UNITED STATES PATENT AND TRADEMARK OFFICE

APPLICATION NO.	FILING DATE	FIRST NAMED INVENTOR	ATTORNEY DOCKET NO.	CONFIRMATION NO.
10/594,849	04/02/2007	Hans-Georg Brauer	628/08	3648
27538 7590 02/03/2011 GIBSON & DERNIER LLP 900 ROUTE 9 NORTH SUITE 504 WOODBIDGE, NJ 07095				
EXAMINER				
REDMAN, JERRY E				
ART UNIT		PAPER NUMBER		
3634				
MAIL DATE		DELIVERY MODE		
02/03/2011		PAPER

Office Action Summary

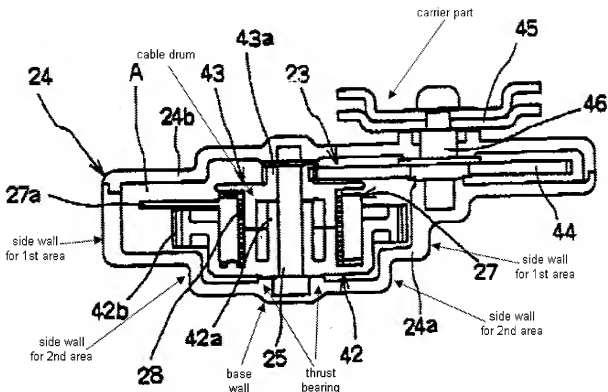
Claims 1-3, 5, 8-12, and 15 are rejected under 35 U.S.C. 102(b) as being anticipated by Shimizu (6,758,012 B2). As shown in detail below, Shimizu (6,758,012 B2) discloses a vehicle having a vehicle door (column 3, line 14, i.e.,) having a module (all inner mechanisms of a vehicle door), a carrier part (24) integrally formed with a drum housing (24a) having side walls, a back wall having a thrust bearing integrally formed thereon, and the housing (24a) having a first diameter area (see Figure below) and a second diameter area larger than the first diameter area (see Figure below).
